Product Change Notification / JAON-04DXFD964

CCB 4541 Final Notice: Qualification of a new lead frame design for selected products available in 8L SOIC package using 8390A die attach and gold (Au) bond wire material assembled at MMT assembly site.

Pre and Post Change Summary

PCN # JAON-04DXFD964

Lead frame Comparison

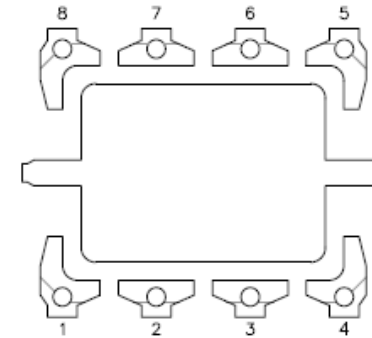
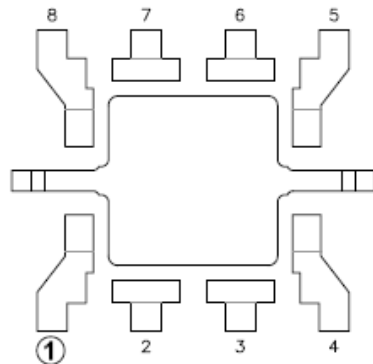
LF STRIP DENSITY: x140
 LF PAD SIZE: 95x130 mils
 LEAD LOCK: NO

LF STRIP DENSITY: x320
 LF PAD SIZE: 95x130 mils
 LEAD LOCK: YES

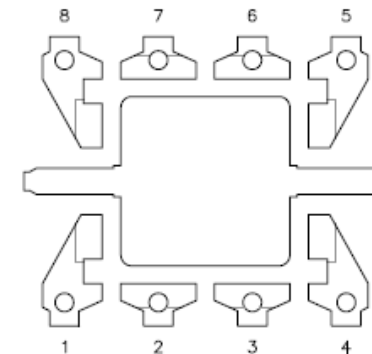
LF STRIP DENSITY: x140
 LF PAD SIZE: 90x90 mils
 LEAD LOCK: NO

LF STRIP DENSITY: x320
 LF PAD SIZE: 90x90 mils
 LEAD LOCK: YES
